TERRA RIDGE NORTH CIVIL CONSTRUCTION PLANS El Paso County, Colorado

V2_Construction Drawings Redlines.pdf Markup Summary 3-20-2023

Glenn Reese - EPC Stormwater (23)

EL PASO COUNTY DEVELOPMENT
 REPLAT TERRA RIDGE LOTS 5 & 6 W/ 11 LOTS IN
 TERRA RIDGE NORTH
**PLAN AND PROFILE
 PIPE CULVERTS**

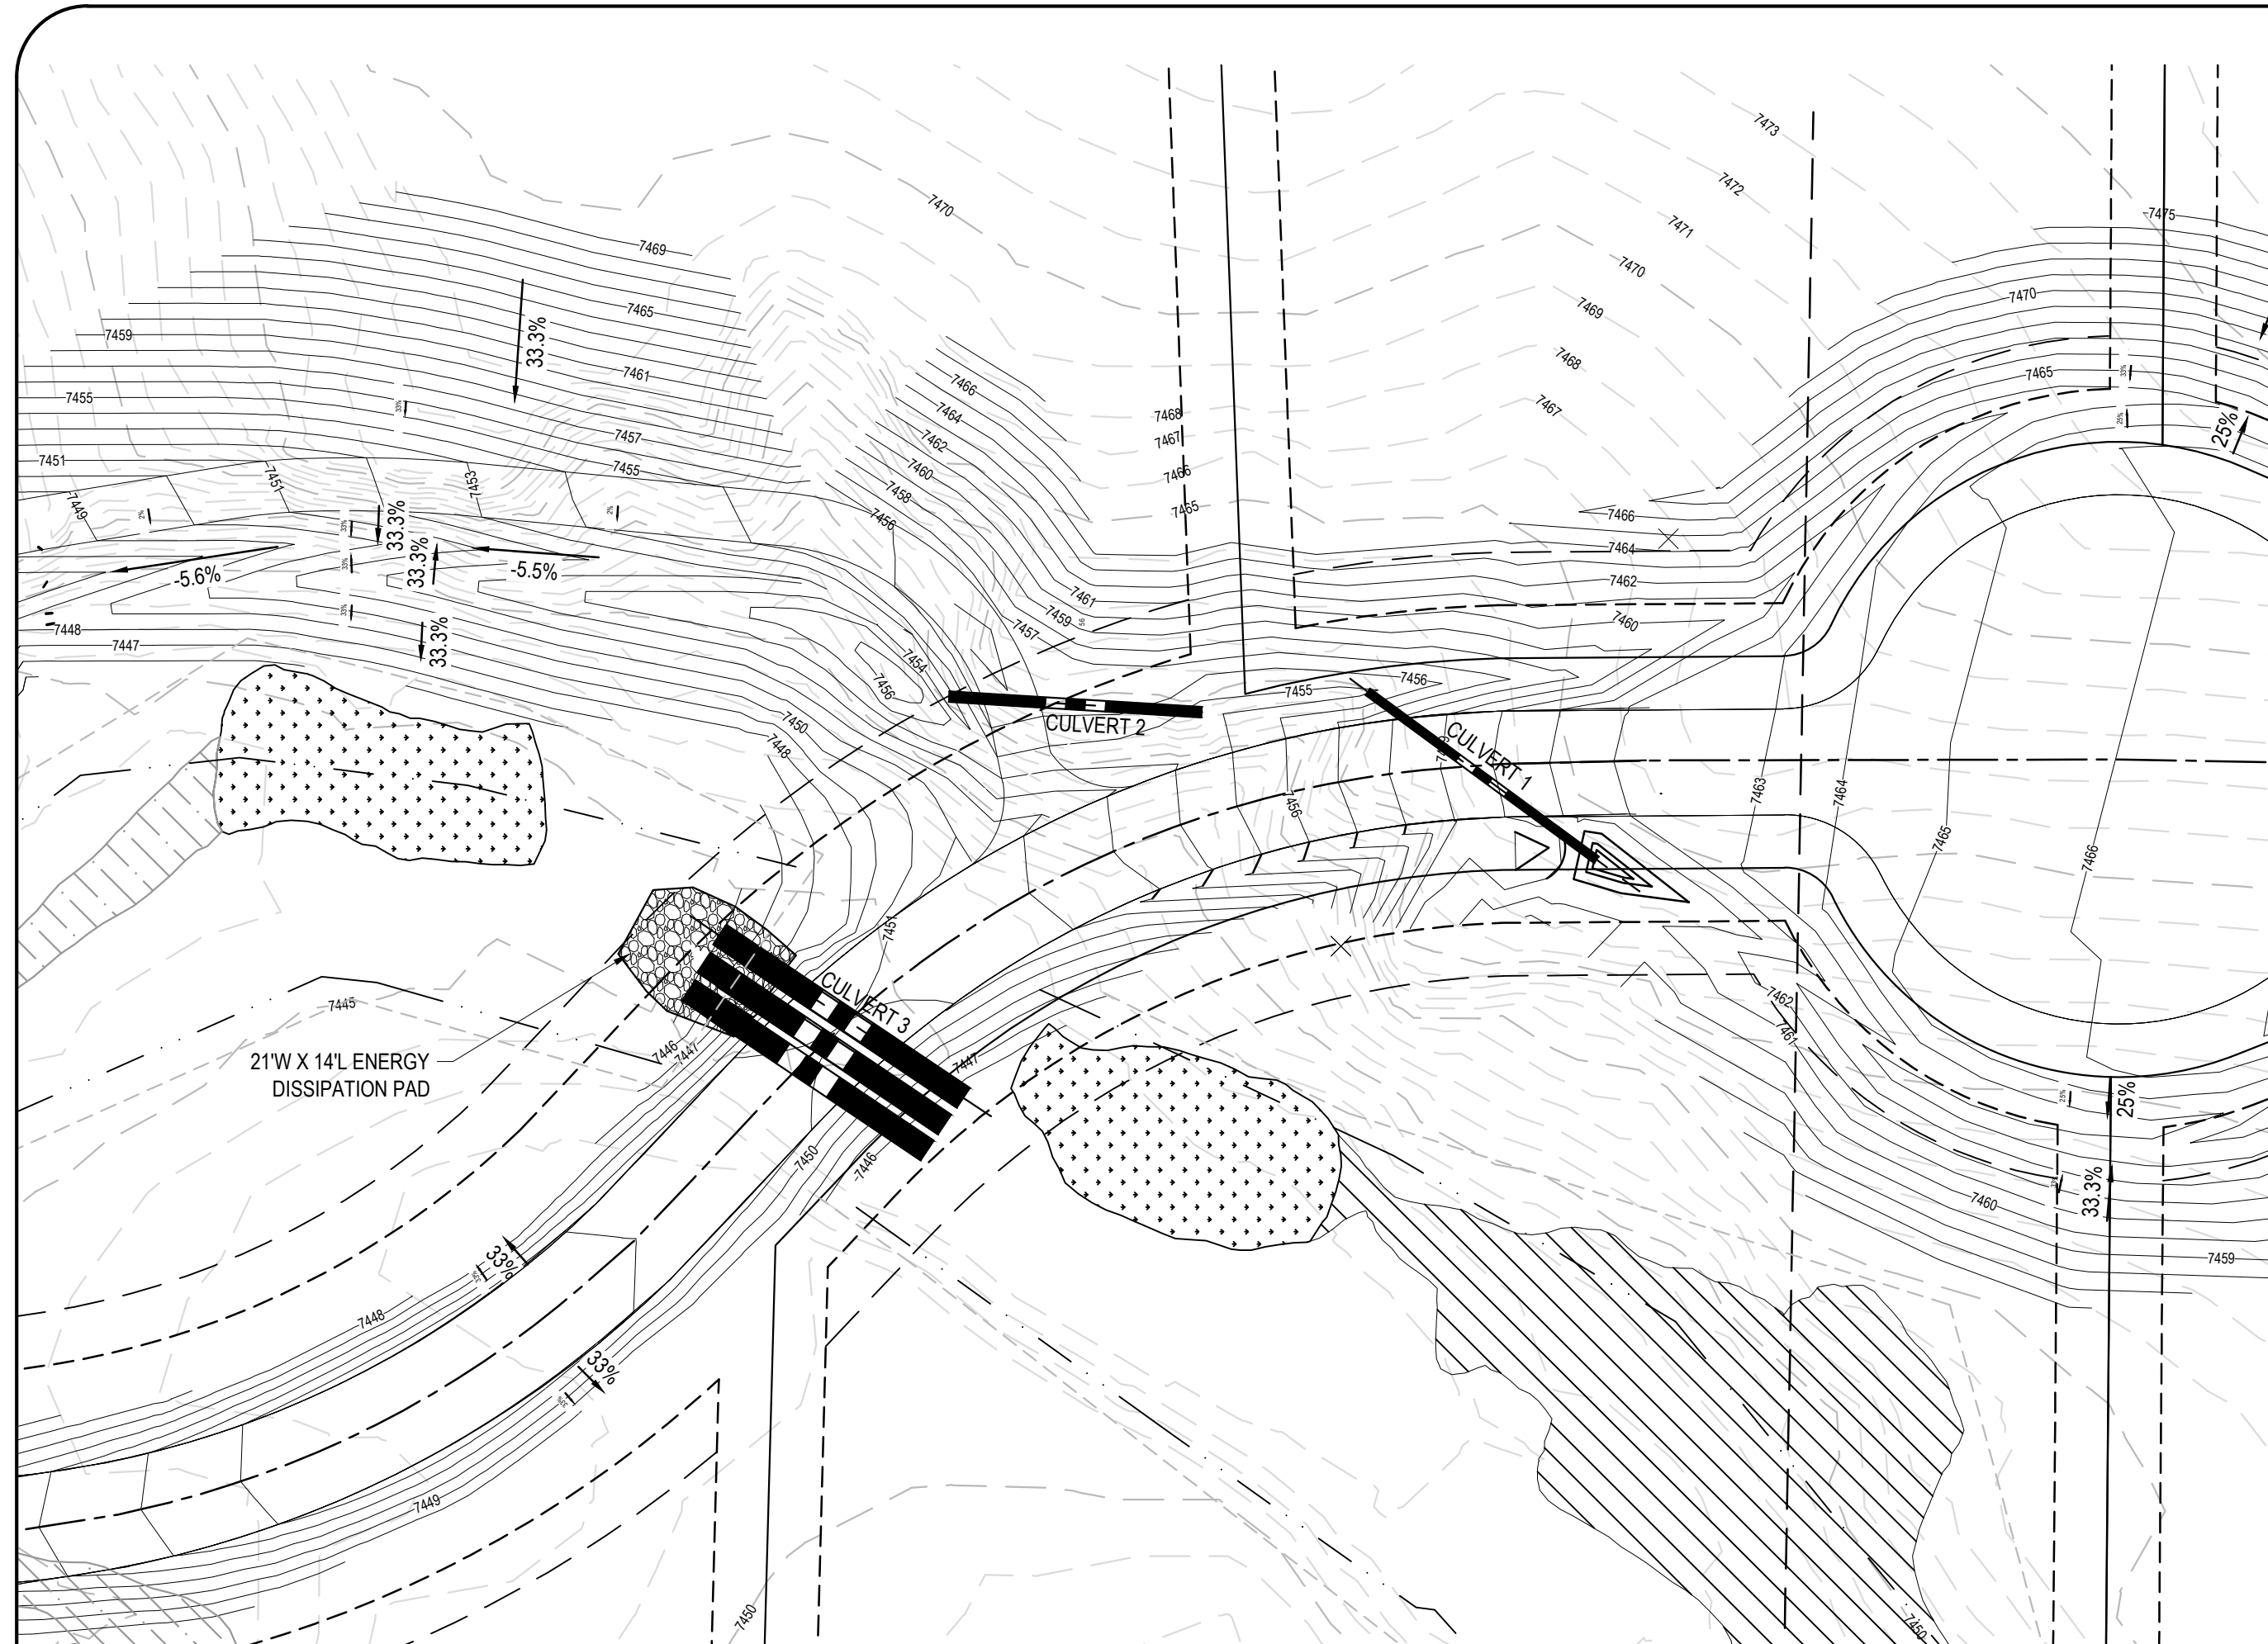
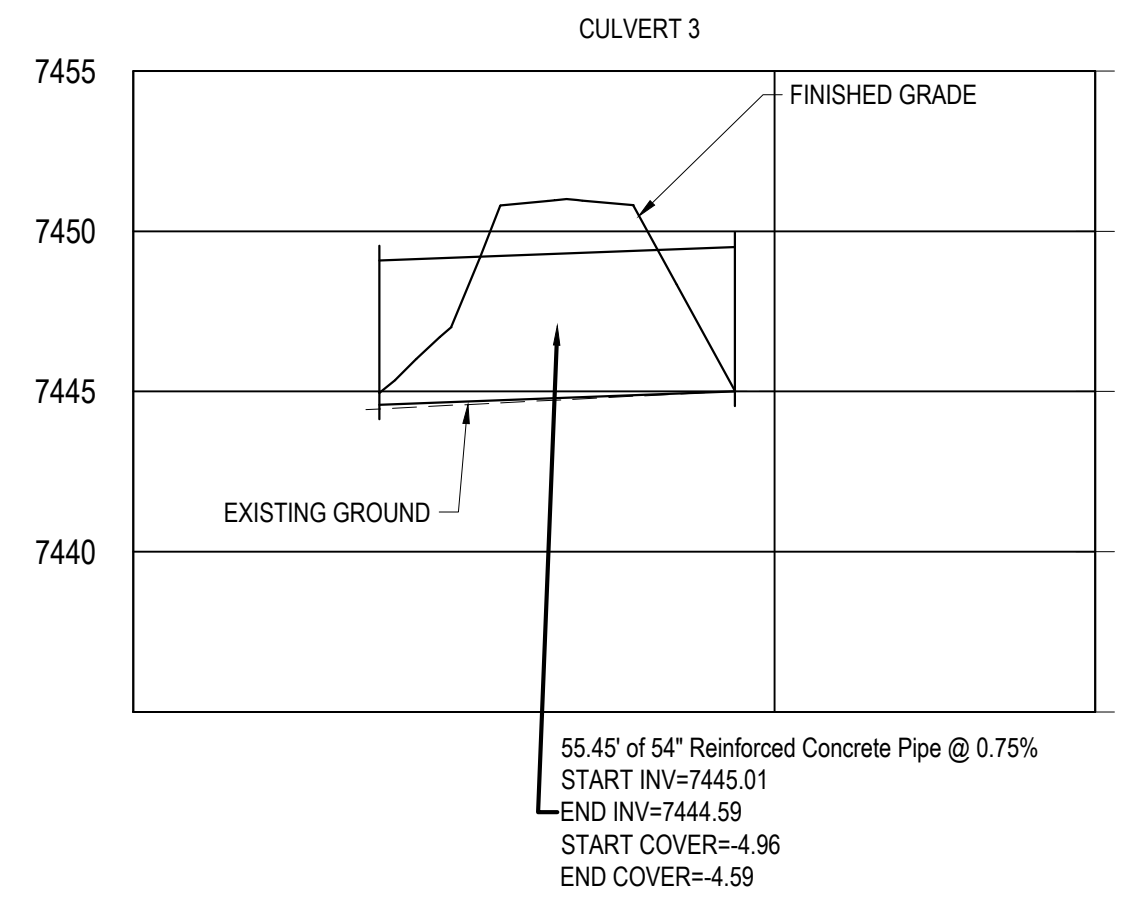
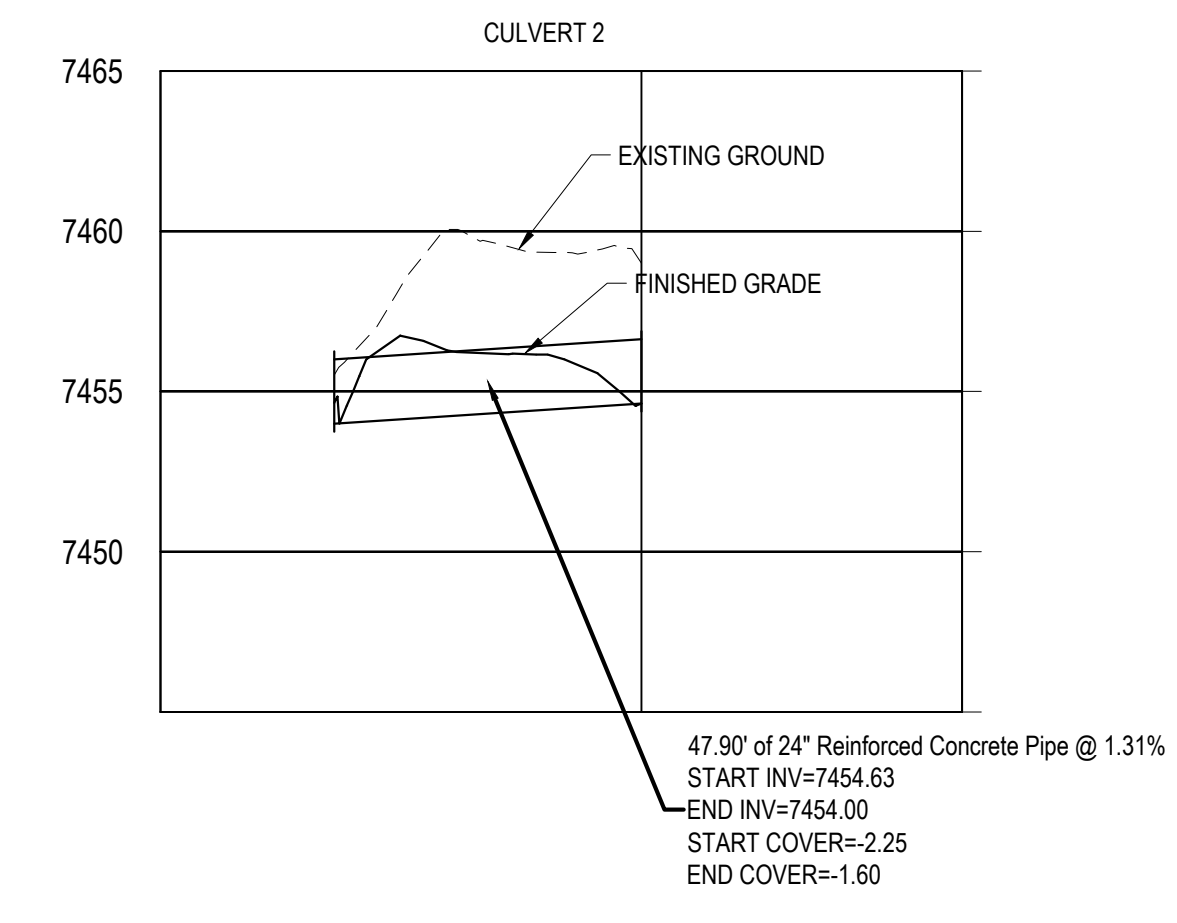
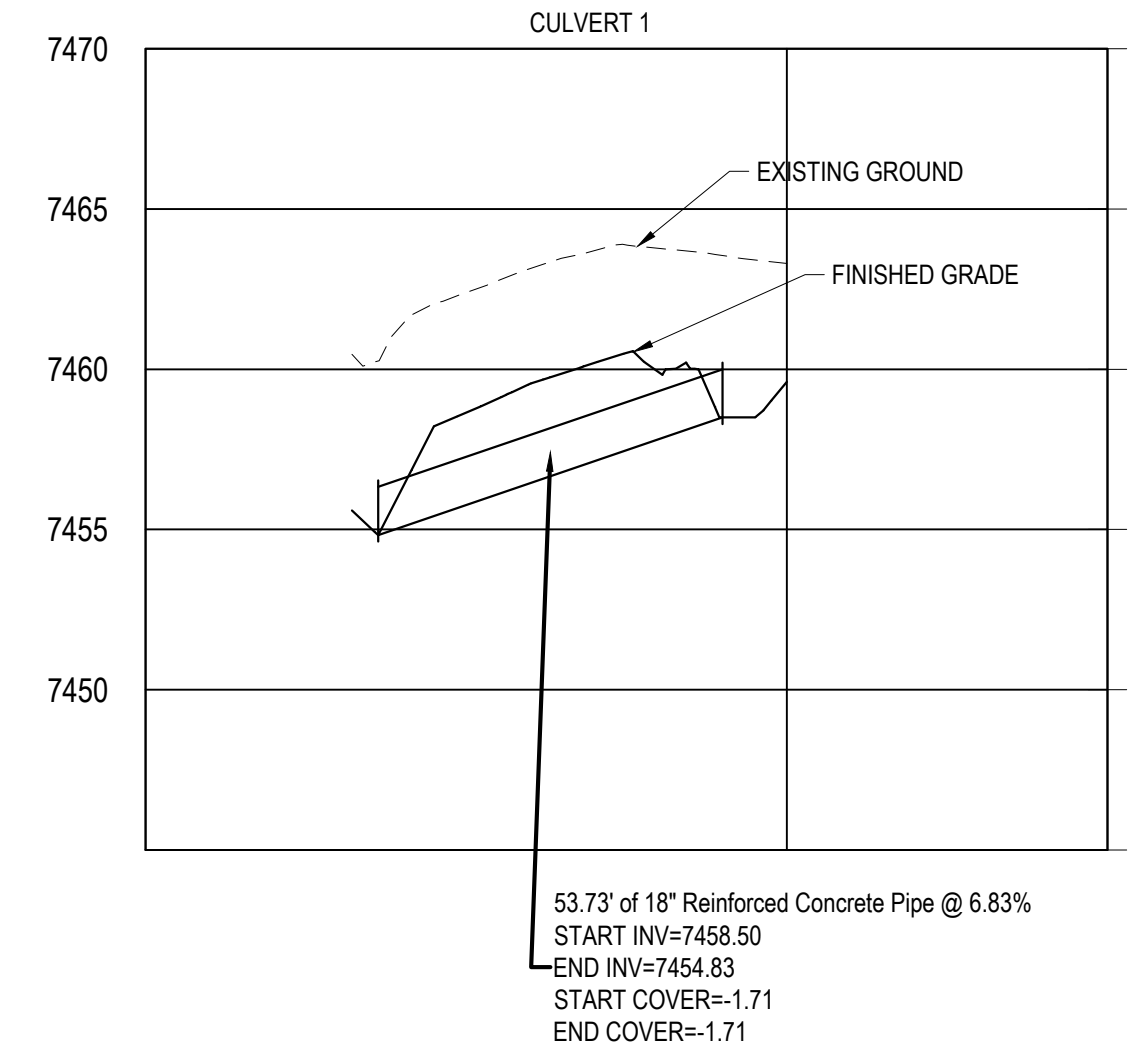
Unresolved comment from Review 1: slope arrow appears to be pointing in the wrong direction.

At what depth? And provide filter fabric if deemed necessary given soils present and expected velocities.

Unresolved. Show and label end treatments for pipe.

EL PASO COUNTY DEVELOPMENT
REPLAT TERRA RIDGE LOTS 5 & 6 W/ 11 LOTS IN
TERRA RIDGE NORTH
DETENTION POND DETAILS

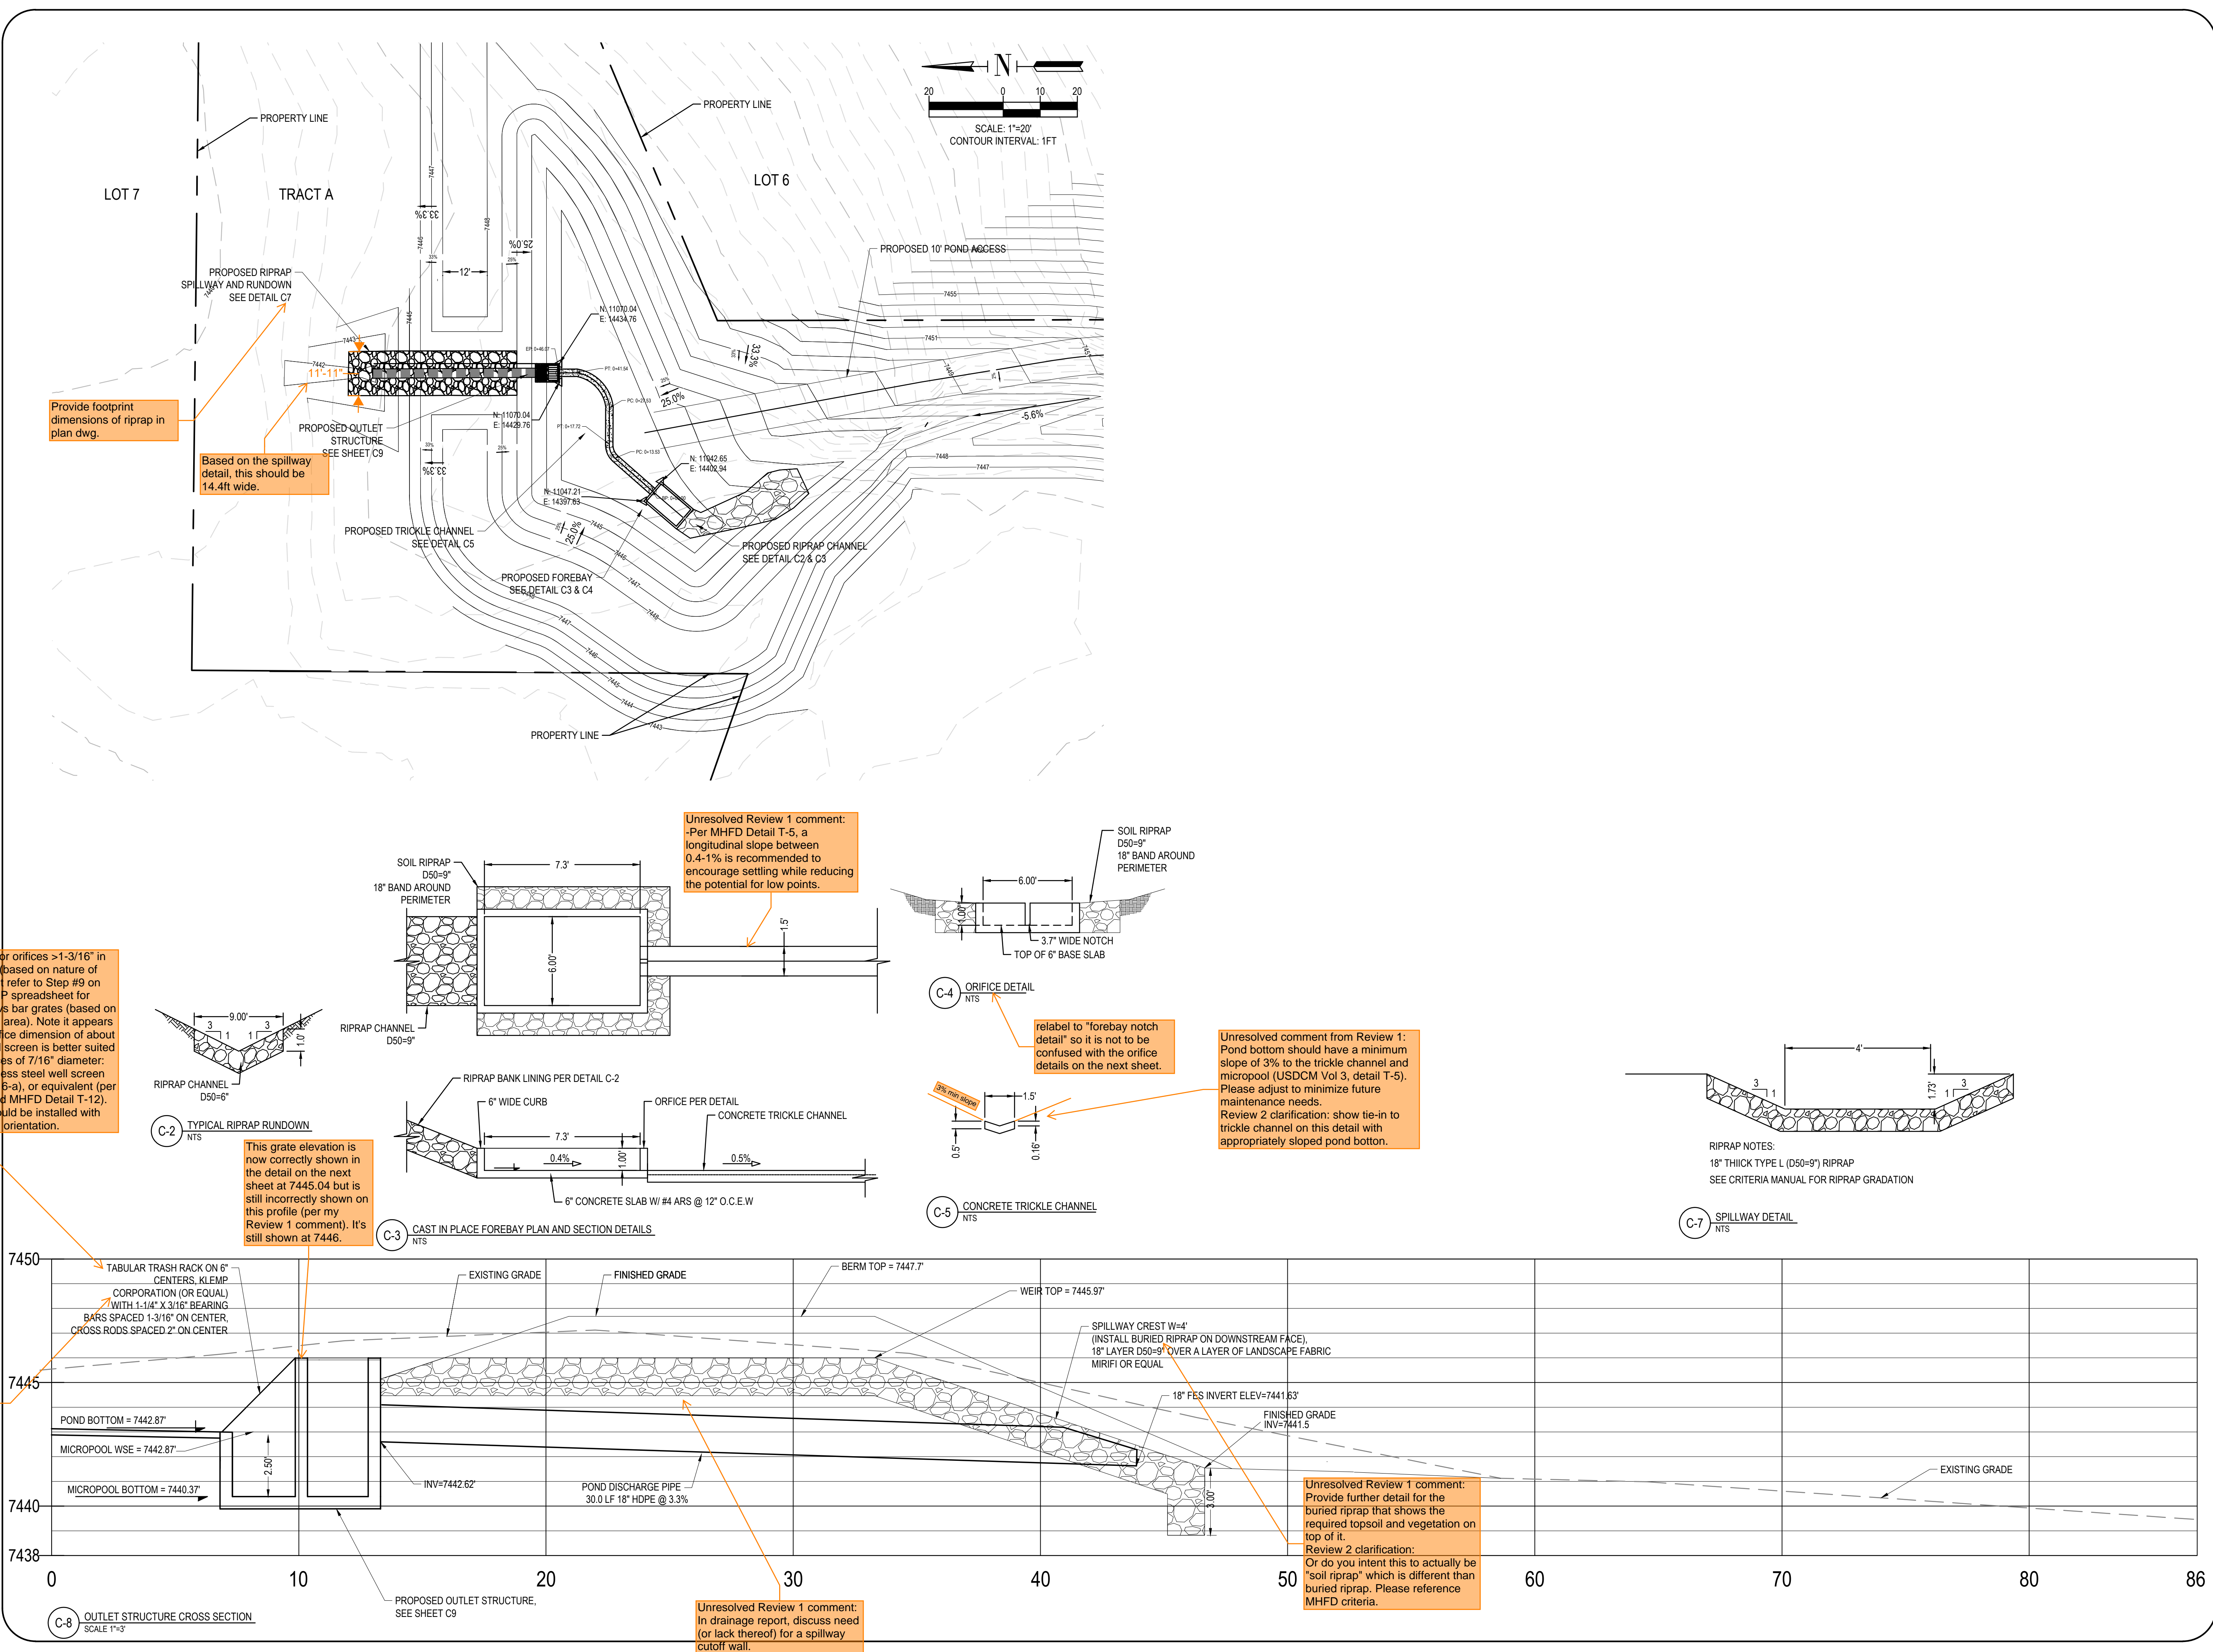
Generally, bar grates are for orifices >1-3/16" in largest length or diameter (based on nature of min bar grate spacing). But refer to Step #9 on the EDB tab of the UD-BMP spreadsheet for when to use well screens vs bar grates (based on R-value, i.e., percent open area). Note it appears the cutoff is at smallest orifice dimension of about 1-1/4", meaning that a well screen is better suited for this pond that has orifices of 7/16" diameter. US Filter or Johnson stainless steel well screen with #93 VEE wire (Figure 6-a), or equivalent (per EPC DCMv2, Chap 4.3 and MHFD Detail T-12). Johnson vee wire type should be installed with exterior bars in the vertical orientation.

Unresolved Review 1 comment: Trash rack to be Amico Klemp KRP Series aluminum bar grate (Figure 6-b), US Filter or Johnson stainless steel well screen with #93 VEE wire (Figure 6-a), or equivalent (per EPC DCMv2, Chap 4.3 and MHFD Detail T-12).

Provide footprint dimensions of riprap in plan dwg.
 Based on the spillway detail, this should be 14.4ft wide.

Unresolved Review 1 comment: -Per MHFD Detail T-5, a longitudinal slope between 0.4-1% is recommended to encourage settling while reducing the potential for low points.

relabel to "forebay notch detail" so it is not to be confused with the orifice details on the next sheet.

Unresolved comment from Review 1: Pond bottom should have a minimum slope of 3% to the trickle channel and micropool (USDCM Vol 3, detail T-5). Please adjust to minimize future maintenance needs.
 Review 2 clarification: show tie-in to trickle channel on this detail with appropriately sloped pond bottom.

Unresolved Review 1 comment: Provide further detail for the buried riprap that shows the required topsoil and vegetation on top of it.
 Review 2 clarification: Or do you intend this to actually be "soil riprap" which is different than buried riprap. Please reference MHFD criteria.

Review 2 clarification: you still need to specify the model/series per our criteria. Just saying "Klemp Corp" is not sufficient information.

This grate elevation is now correctly shown in the detail on the next sheet at 7445.04 but is still incorrectly shown on this profile (per my Review 1 comment). It's still shown at 7446.

Unresolved Review 1 comment:
In drainage report, discuss need (or lack thereof) for a spillway cutoff wall.

Based on the spillway detail, this should be 14.4ft wide.
